SITE RECORD SHEET

Aconex Ref: OTH-PUR-TH-ZZ-SRS-A-0601	**Date:** 24/04/2024
Document Title: Albert Memorial – Confirmation of High Level Repairs	**Revision:** -
Visit By: Jamie Coath, Andrew Bailey (Purcell)	**Status: -** For Information
Attended: See below sections	**Attachments:** Photos embedded where applicable

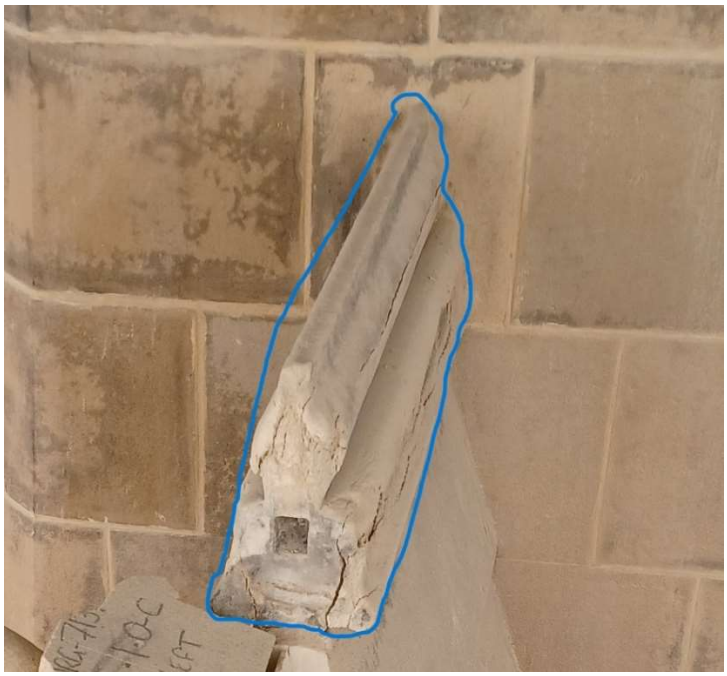
No	Item/Room	Comments	Action
		Following site review on 04.04.24, a number of high level repairs have been identified as being required.	
1.1	Albert Memorial – South Gable	Coping stone to gable on south elevation. Stone badly fractured. Full replacement recommended. 	
1.2	Albert Memorial – South East roof gablet	Considerable damage to end of small gablet. 1nr. carved indent repair required to end of ridge to match intact detail on North East roof gablet (two views of same gablet shown below)
